*Structural Integrity Review for CCR Closure Plan  
Plant Barry  
Alabama Power Company  
Bucks, AL*

Mobile Bay National Estuary Program  
Mobile, AL

D'Appolonia Engineering Div. of Ground Technology, Inc.  
Pittsburgh, PA

**Figure 4: CCR Excavation Area Adjacent Perimeter Dike - Before (upper cross section) and After (lower cross section)**

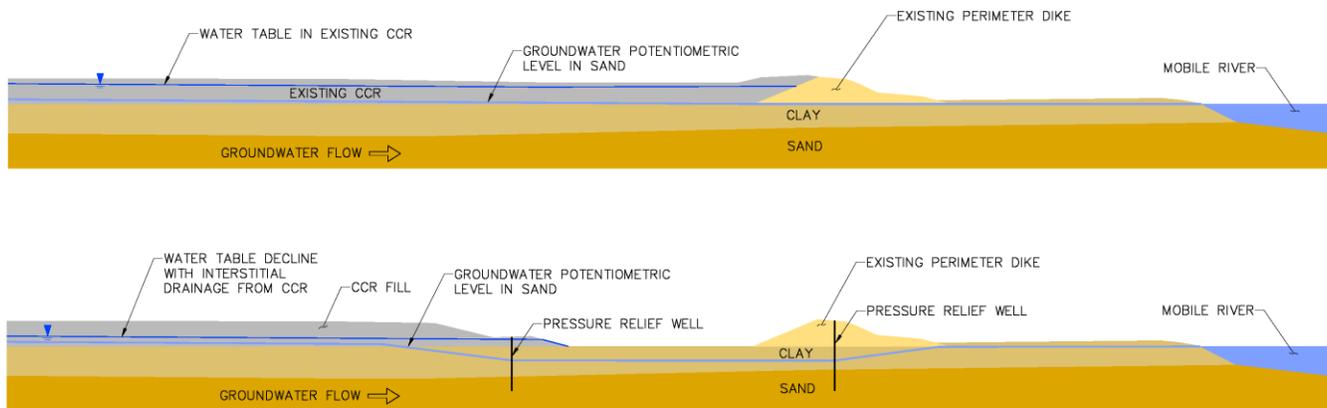
The depth of CCR to be excavated is reported to range between 5 and 25-feet. Excavation is planned to be conducted in stages whereby the CCR will be removed in 5 to 10-foot vertical increments until the required depth is accomplished. A bridging lift of bottom ash or other granular material placed over exposed CCR is proposed to stabilize the material for excavator operation and hauling equipment. Figure 4 presents a cross section illustrating the CCR excavation area adjacent the existing perimeter dike (without exaggeration of vertical scale). As shown in the excavation sequence (before and after initial excavation of CCR) of Figure 4, as

the excavation depth advances, interstitial drainage from the CCR will cause a decline in the water table, and this drainage will be collected in sumps and pumped to the WWTP.

Pressure relief wells will be installed if needed to pump groundwater from the foundation sand and address the potential for sand boils and heave within the excavation, allowing improved construction conditions, and provide protection of the structural integrity of the existing perimeter dikes. This is illustrated in the lower cross section in Figure 4, where pressure relief wells would pump groundwater from the foundation sand, relieving pressure and lowering the potentiometric level (pressure level) in the sand, and lowering seepage induced forces on the clay that can cause sand boils and heave. Operation of the pressure relief wells is a temporary measure to enable excavation and construction at the clay surface. With advancement of CCR excavation to the underlying clay, a verification protocol will be implemented as discussed subsequently, and a granular (sand or similar fill) bridging layer may be placed as needed on the clay layer to maintain suitable construction conditions.

Excavation is planned to be performed in a phased approach with two distinct areas being excavated at a given time. Pressure relieve wells and preloading will likewise be conducted as necessary in areas of phased excavation activity. The CCR Closure Plan does not provide specific information on geotechnical monitoring or criteria for determination of these temporary stabilization measures.

**Figure 6: Soil Containment Berm, Internal Drainage System, and Cutoff through Bridging Lift**

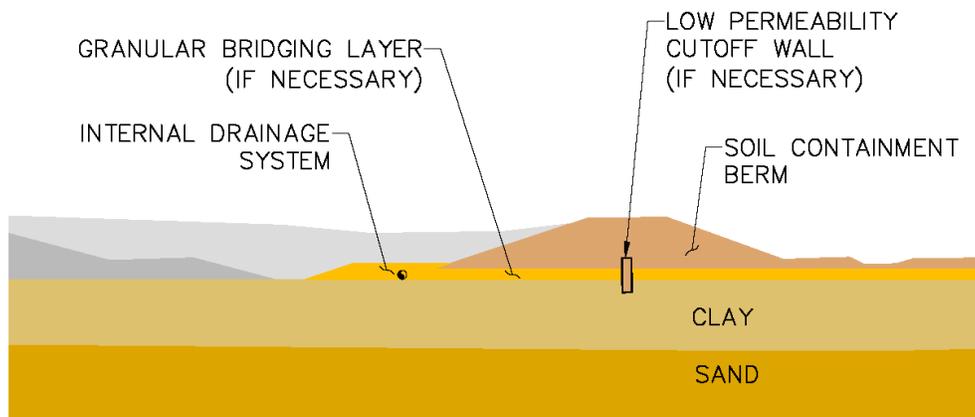
as shown in Figure 5. An internal drainage system will be installed on the upstream slope of the berm to collect interstitial water that drains from the CCR materials, as indicated in Figure 6. The drainage system will include a perforated pipe and granular stone collection corridor, sumps, and forcemains which will operate via pumps during and after closure as needed. The soil containment berm is designed to be approximately 20-feet in height, constructed of cohesive soils on the foundation clay layer or, if necessary due to soft conditions, on a granular material placed on the clay as a bridging lift. For such instances where a bridging lift is required, the physical barrier of the soil containment berm may be extended by a low permeability cutoff wall (specified as silty or clayey sand, silt, or clay backfill) into the foundation clay.

Interstitial water from the CCR material within the consolidated CCR area will be collected in the internal drainage system and pumped through forcemain piping to the WWTP. Upon completion of CCR fill placement and installation of the cover system, drainage to the internal drainage system will diminish, ultimately limited to groundwater seepage from the underlying sand up through the clay foundation layer.

Figure 9: Closure Plan Construction Phasing Plan

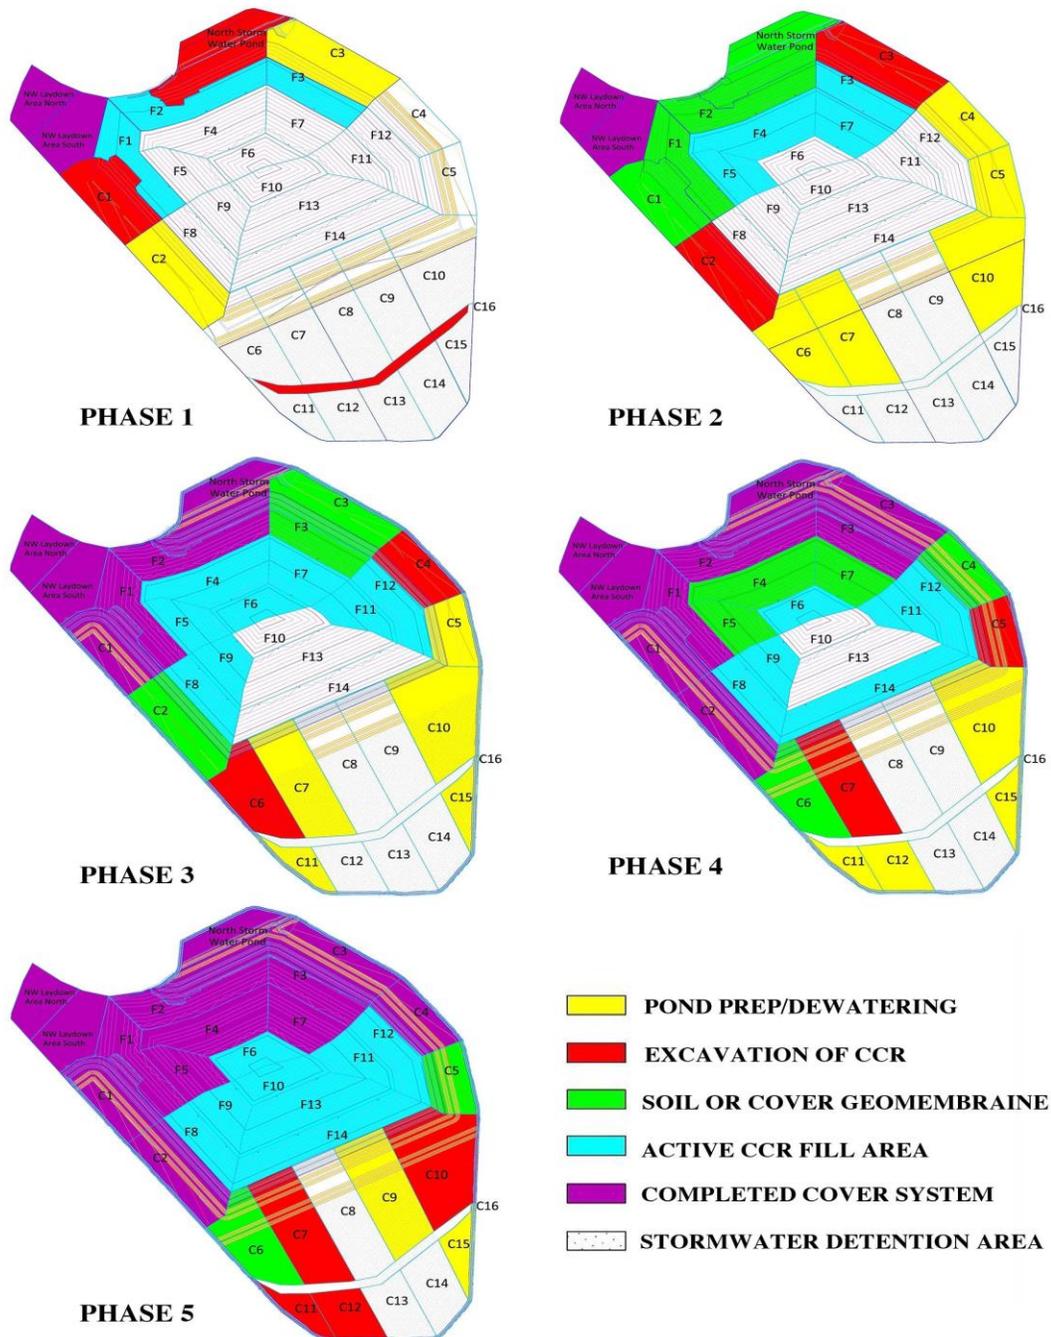
The CCR is saturated, loose material within the Ash Pond covering approximately 597 acres, and dewatering and excavation requires sequential steps to achieve closure requirements. The Amended CCR Closure Plan includes the construction sequence to perform the associated tasks in phases, including pond dewatering, CCR excavation, active CCR fill placement in the consolidated CCR fill area in the central portion of the property, soil or cover geomembrane placement, and completed cover system areas. The conceptual phasing plan is shown in Figure

9, which depicts the Ash Pond limits and anticipated sequencing of closure activities over the first five phases generally beginning in the north portion of the site and proceeding south. Areas labeled C1 through C6 roughly represent the location and sequence of initial CCR excavation or Cut (C) areas, while areas labeled F1 through F14 represent the consolidated CCR footprint where the excavated CCR Fill (F) will be placed and capped with the cover system. The laydown area in the northwest portion of the site will provide for equipment storage.

The conceptual phasing plan is intended to be flexible, accomplish work in multiple areas, while meeting stormwater and contact water management requirements. The duration of each phase will be variable and depend on field and climatic conditions. During Phase 1, dewatering of ponded areas and removal of the separator dike in the south portion of the Ash Pond will be conducted. The area for the North Storm Water Pond and C1 will be excavated, while Areas C2 and C3 are dewatered in preparation for CCR excavation. Excavated CCR during Phase 1 will be placed as indicated in Areas F1 through F3, as shown in Figure 9.

Phases 2 through 5 are also shown in Figure 9, and illustrate the continued dewatering and CCR excavation and fill placement areas, followed by cover placement advancing from north to south. With completion of Phase 5, the northern slope and portions of the eastern and western slopes, soil containment berm, and stormwater ponds have been completed including the cover system comprising a geomembrane liner. The southern portion of the site is continuing to be dewatered during Phase 5 and the CCR excavated and placed as fill in the consolidated CCR footprint. Subsequent phases will be constructed until all CCR has been removed from the southern portion of the site completing the CCR fill and geomembrane cover system, the soil containment berm and stormwater ponds are completed, and the soil cover established for the stormwater stilling basin at the south end of the site.
